**PUBLIC UTILITY COMMISSION OF OREGON  
STAFF FINAL REPORT  
SPECIAL PUBLIC MEETING DATE: December 6, 2022**

**SUBJECT:** CASCADE NATURAL GAS:  
(Docket No. LC 76)  
Acknowledgement of the 2020 Integrated Resource Plan Update.

Figure 3: Current Baker City System under CNG's Current Cold Weather, Design Day Parameters

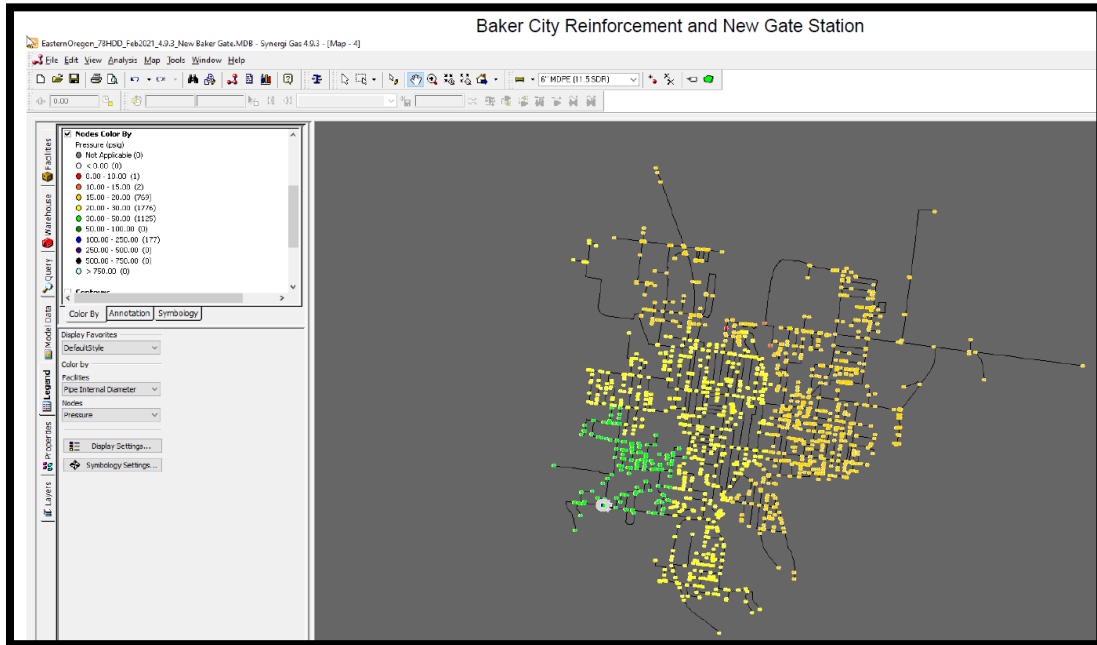
There appears to be only one node fully below 10 psig during the design day event. Further, there are two nodes between 10 to 15 psig, with an additionally 760 between 15 to 20 psig. As such less than 1% of the Baker City nodes fall below 15 psig under the design day criteria. While future demand may drive the need for upgrades, especially if non-pipe alternatives are not explored and/or piloted, the near-term the need for the project does not appear imminent. Further, Cascade's planning engineers' filing only mentioned one other alternative investment: adding an additional 1,200 ft. of six inch pipe to the proposed projects. This would make the Baker City project even more expensive than the \$1.75 million cost initially proposed in the IRP Update.

Later in the IRP Update process Cascade stated that a potentially, less expensive non-pipe alternative may be workable. Staff appreciates the Company's flexibility in this regard but shares the data above to highlight a concern regarding how distribution system projects were presented in this IRP Update. While this \$1.75 million distribution system upgrade could potentially be necessary in the future, it was not needed in this IRP Update. It also caused Staff to posit that more rigorous set of analysis should be gathered before proposing a project in an IRP. To this end, we have included Attachment A as suggested set of questions to be addressed when considering proposing a growth-driven distribution system project. Staff plans to introduce these

**Recommendation:** N/A as Cascade removed the project from acknowledgement consideration in its Reply Comments.

Figure 4: IRP Update Figure 8 - Ontario Before Proposed Reinforcement

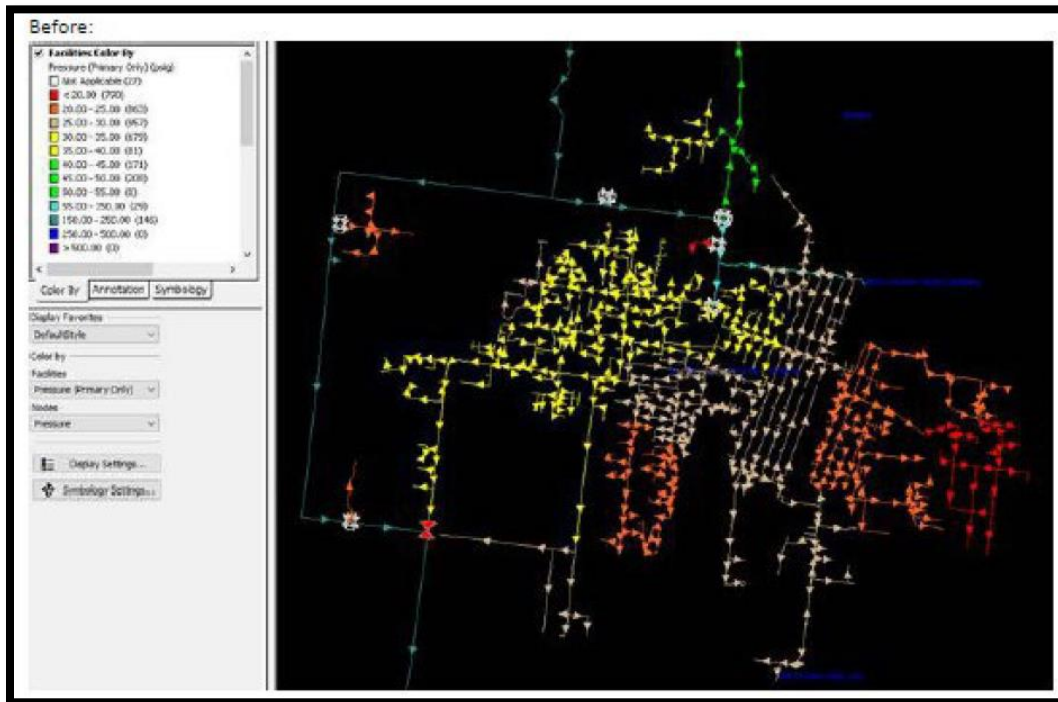
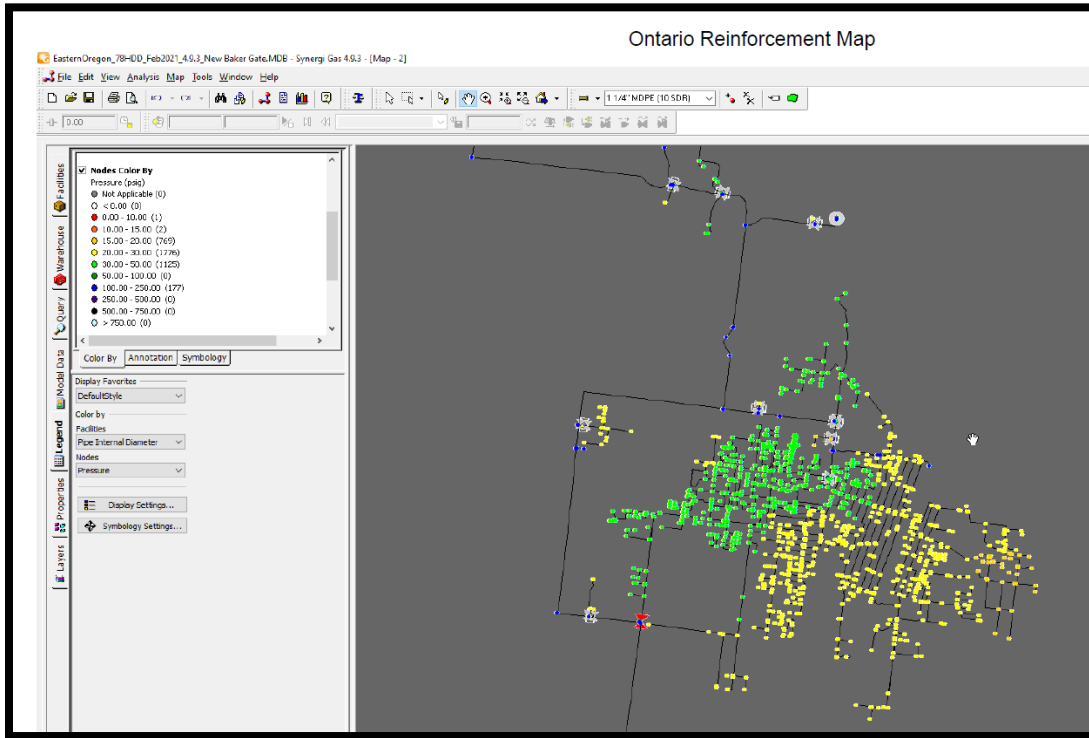
Much like the Baker City project, Cascade provided a screenshot of a constrained distribution system at design day maximums. An updated screenshot with more granular psig data, per a Staff data request, showed Ontario distribution system, including the east side, had sufficient pressure under the most stressful peak period.

Figure 4 is from the IRP Update. In this system model any node equal to or below 20 psig on the cold weather, design day maximum appears in red. The second screenshot is with a more granular representation of the psig under the cold weather, design day constraint.

Note that only two nodes of the Ontario system appears to experience less than 15 psig under design day criteria currently. Further, Cascade notes that this is not a fast growing area.<sup>24</sup>

As such, this reinforces Staff’s belief that this proposed \$1.23 million project falls under the category of growth-driven and does not need to be acknowledged now. The project should demonstrate in a future IRP how it meets Staff CPP criteria for distribution system projects.

**Recommendation:** Do not acknowledge Ontario Reinforcement.
